FINAL ENVIRONMENTAL STATEMENT

FLOOD CONTROL AND ALLIED PURPOSES

IAO STREAM

MAUI, HAWAII

ALTERNATIVE PLAN B

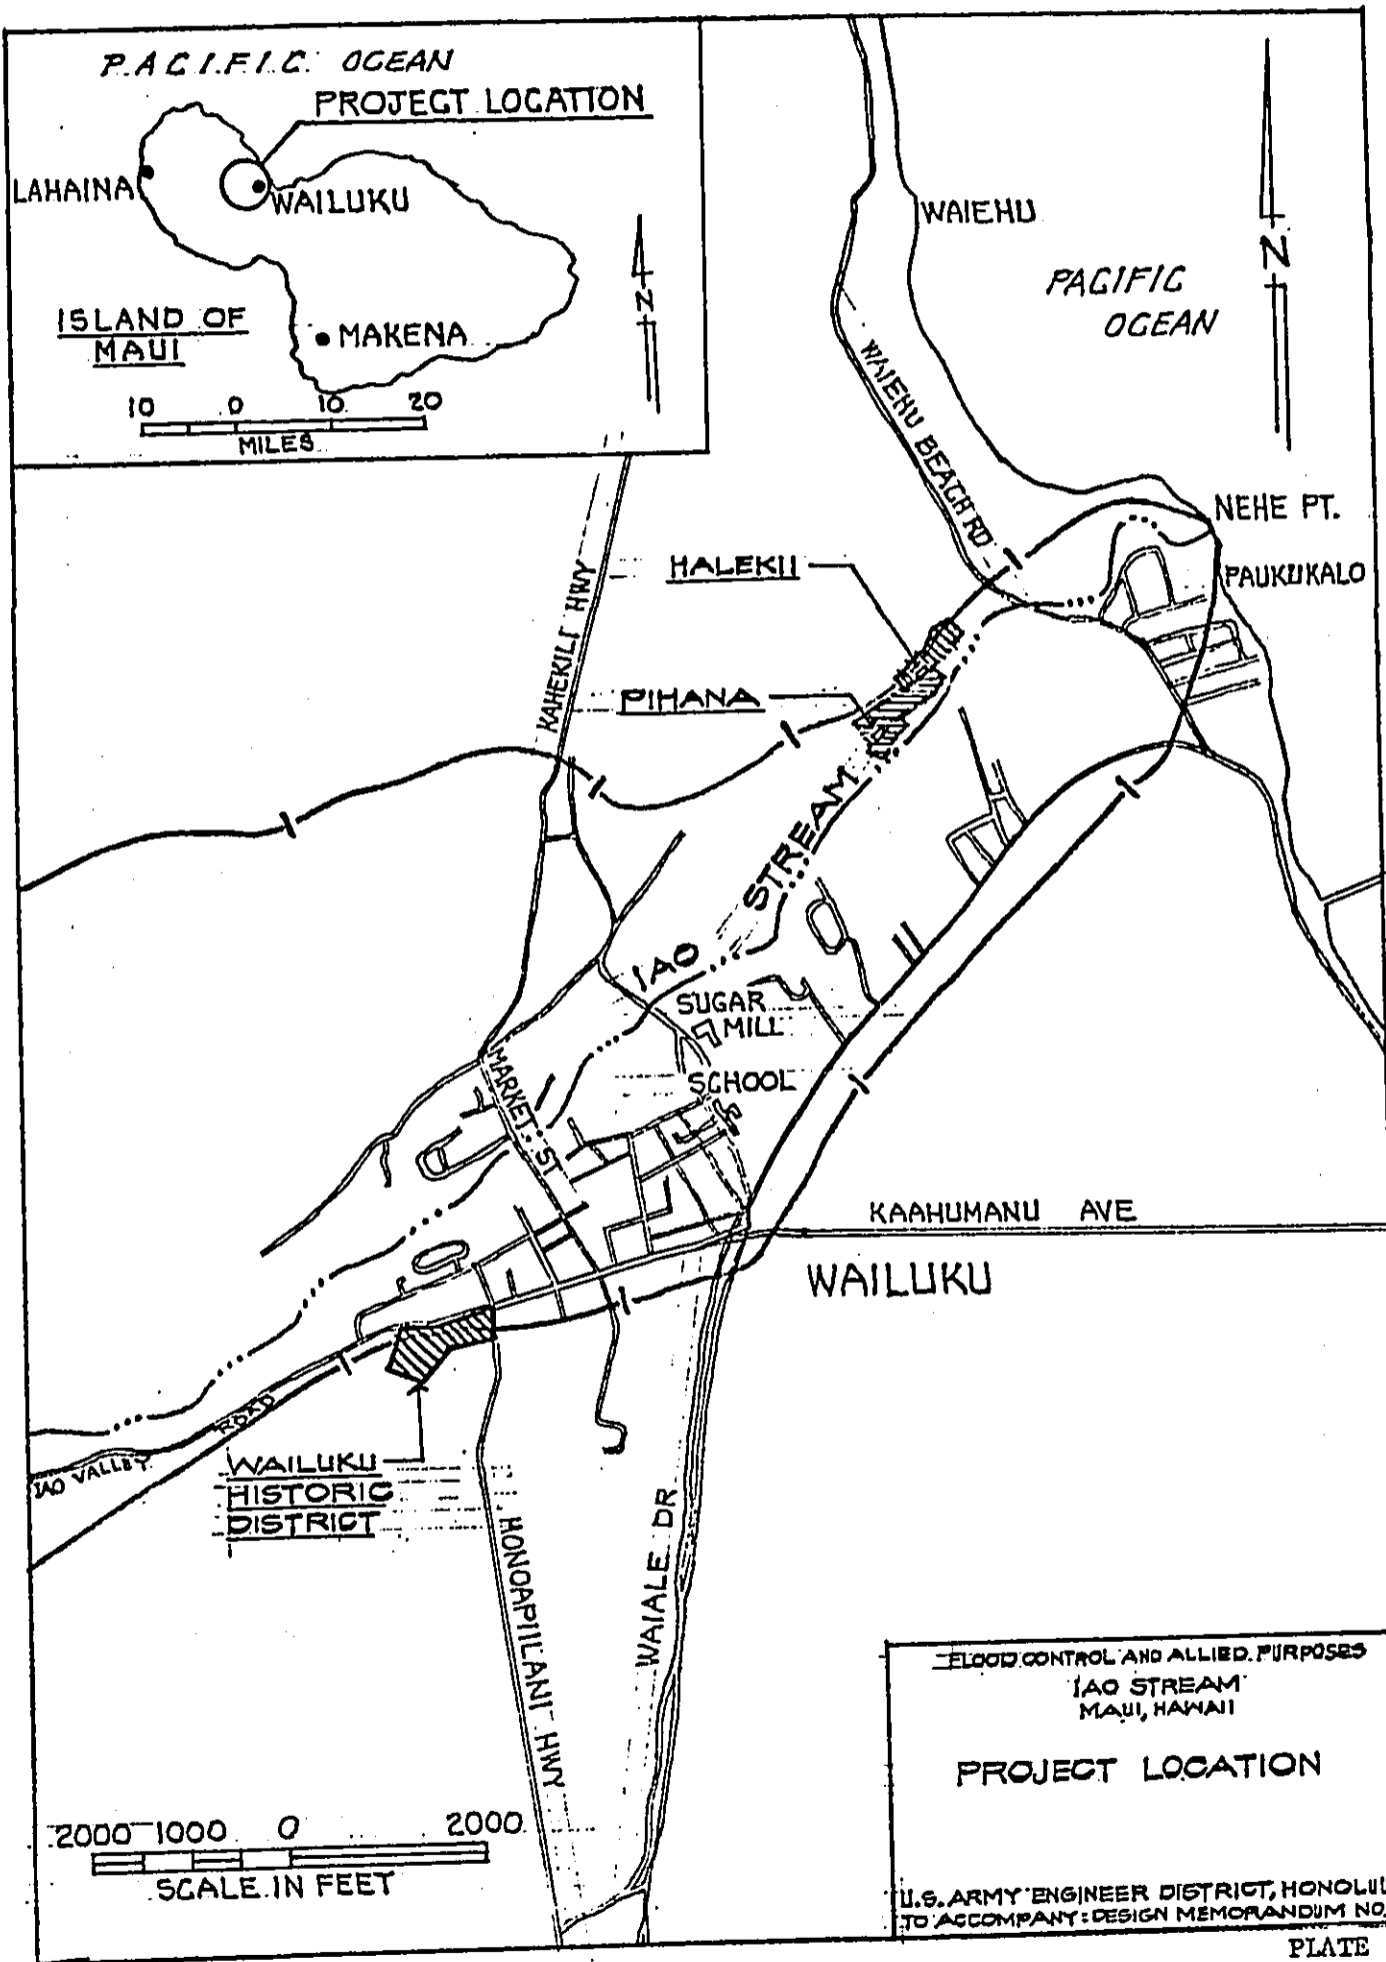
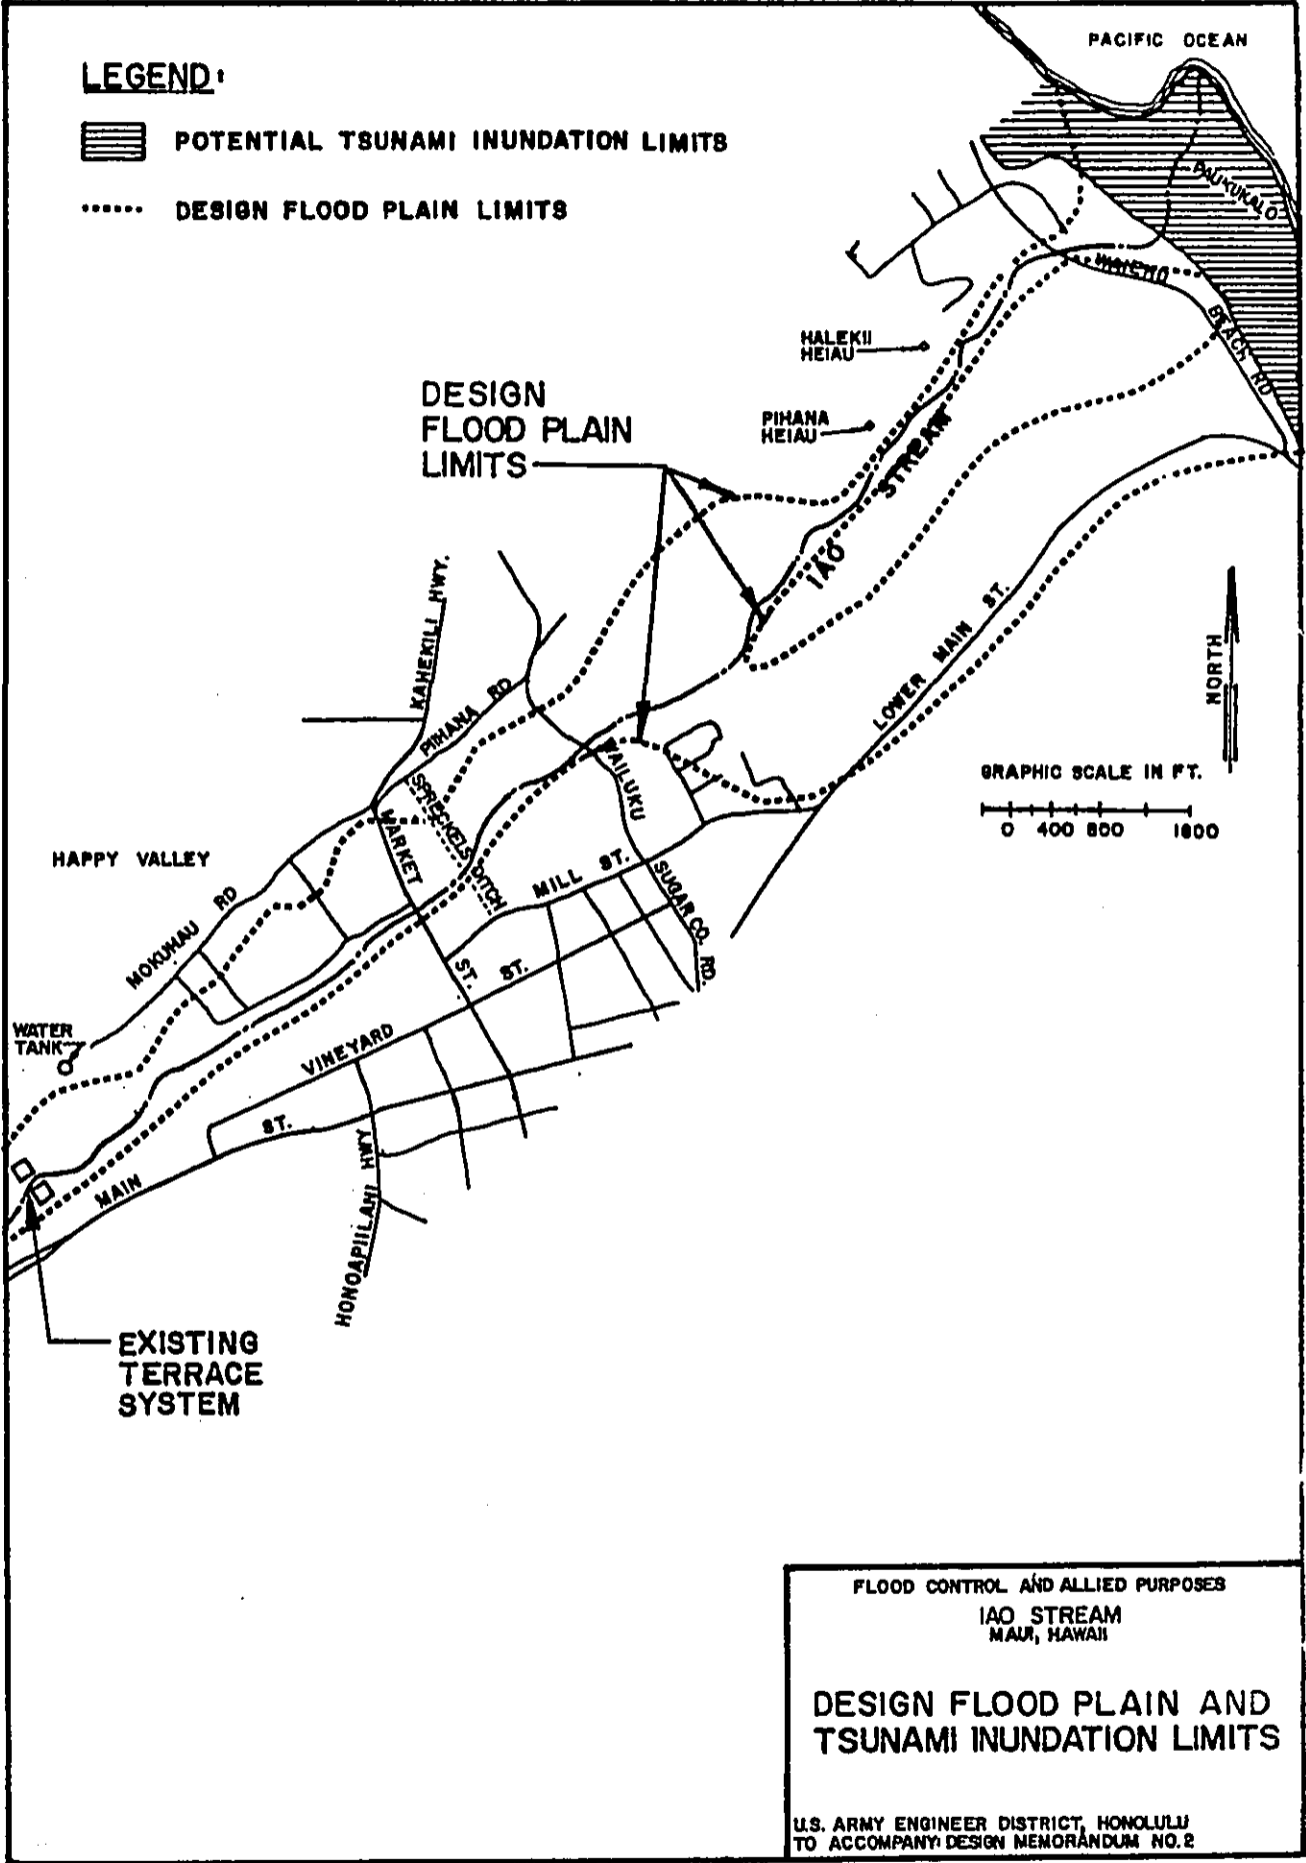
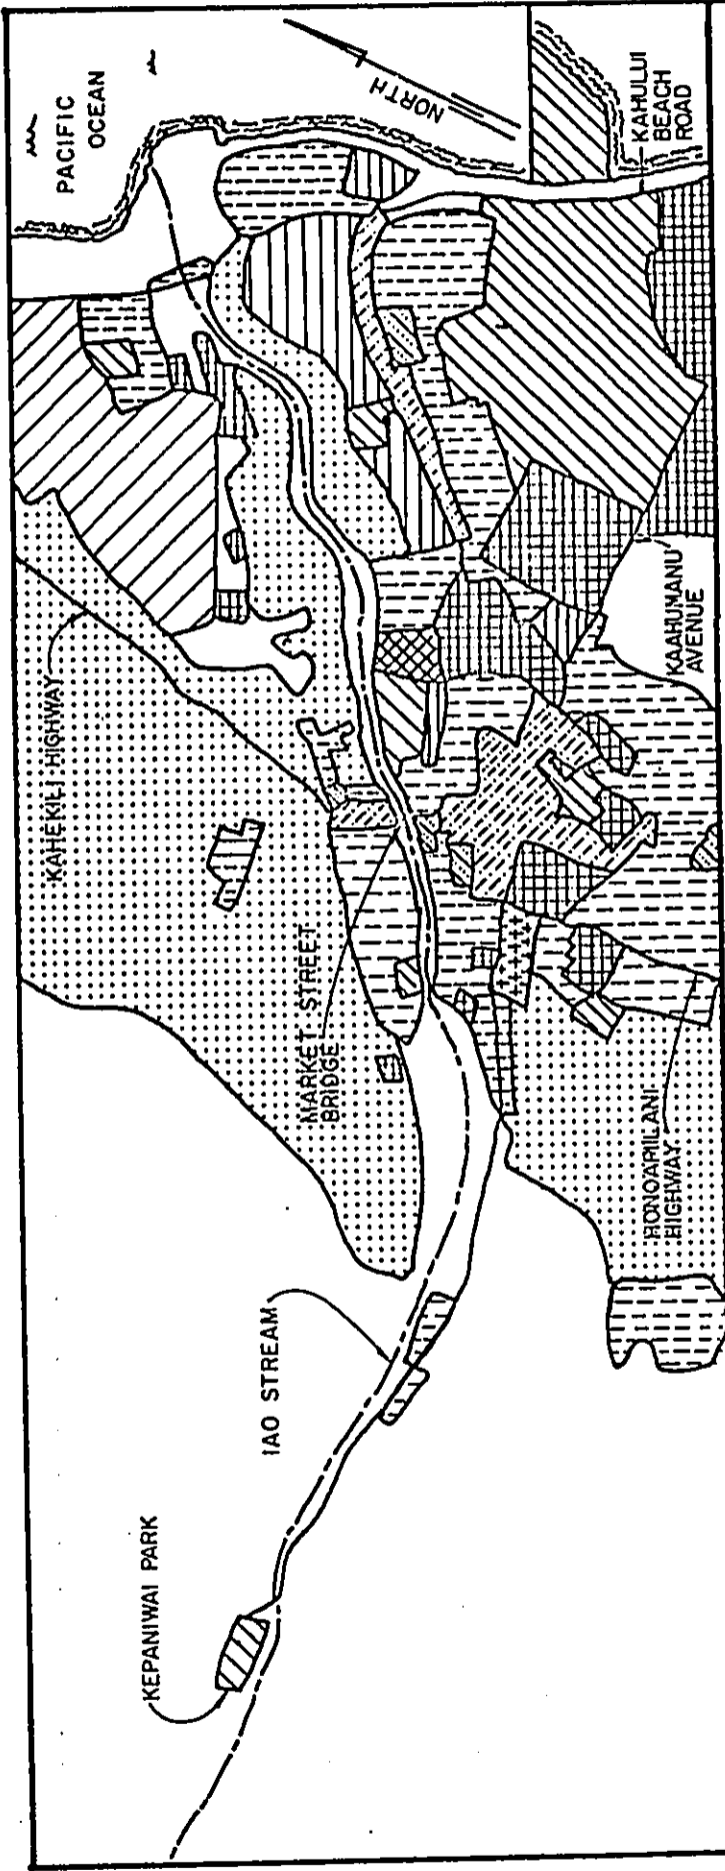
Comment: A detailed diagram showing pre- and post- project conditions for inundation should be included to clarify the differences in area flooded or eroded.

Comment: Will flooding be compounded in the area of the Pihana Heiau? Reference is made to Plate 3 and to paragraph 4.6 of the draft statement.

Response: Plate 3 shows the pre-project Iao Stream design flood plain limits as well as the potential tsunami inundation limit. Plate 1 shows the post-project condition with the recommended project. In this case, flooding is limited to the left bank canefields under the design flood conditions. A slight increase in flood plain at its fringes (7 acres) is expected, but is not considered significant in terms of erosion because of the low velocity flows at the fringes and the level topography. See U.S. Soil Conservation Service comments. Overbank flows are also expected downstream of the channel improvements near the shoreline.

Response: As shown on Plate 3, Pihana Heiau is on high ground, outside the limits of the design flood plain (magnitude, 26,500 cfs). The reference to paragraph 4.6 is clearly misquoted. As printed, paragraph 4.6 states that "the canefields on the left bank between Market Street and the Pihana Heiau Site will remain unprotected." This statement is graphically depicted on Plate 1 and described in detail in the project description and impact sections of the draft statement.
